Service Bulletin

Subject: Malfunction Indicator Lamp (MIL) Illuminated, DTC P0442 and/or P0455 Set

Models: 2012-2013 Chevrolet Express 3500-4500 Cutaway Vans
2012-2013 GMC Savana 3500-4500 Cutaway Vans
Equipped with Upfitter Body and Side Mounted Fuel Tank

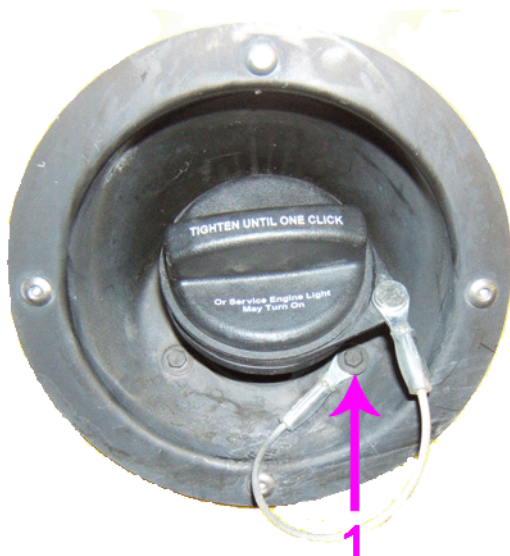
This condition may be caused by the fuel cap tether binding when installing the fuel cap and not allowing the fuel cap to seal completely or by the fuel cap tether being trapped between the fuel cap seal and the fuel fill pipe, not allowing the fuel cap to seal completely.

The fuel cap tether will need to be repositioned from its current attachment point within the fuel fill pipe housing to the external 3 o'clock position on the fuel fill pipe housing edge.

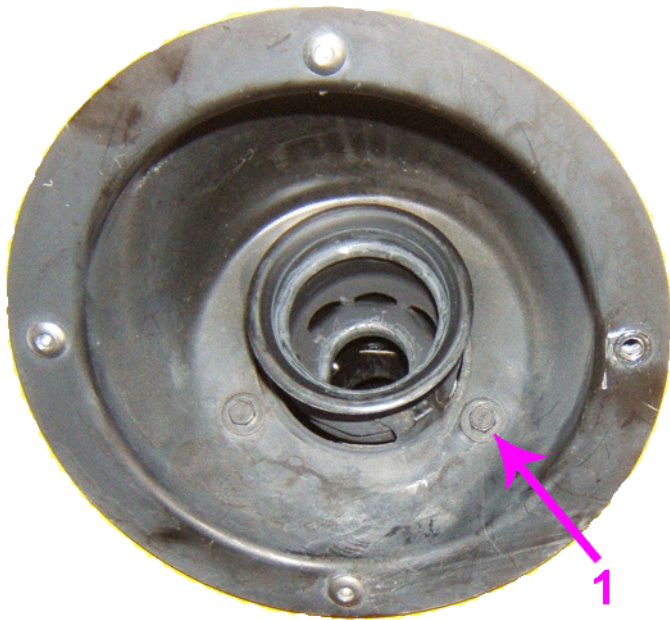
4. Remove the fuel cap tether fastener (1) from its attachment point within the fuel fill pipe housing.

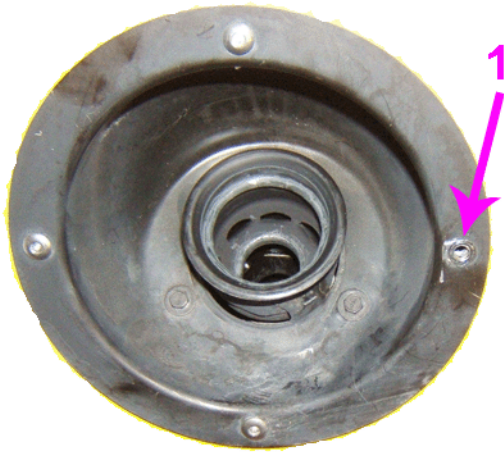
5. Reinstall the fastener (1) to its original attachment point within the fuel fill pipe housing.

6. Remove the fastener at the external 3 o'clock position on the fuel fill pipe housing edge.

7. Install the gas cap.
 - 7.1. Orient the fuel fill cap tether, with the crimp side (not shown) of the tether terminal (1) **towards** the vehicle box as shown.
 - 7.2. Install a new fastener through the fuel fill cap tether terminal into the external 3 o'clock position attachment point on the fuel fill pipe housing edge and secure it.
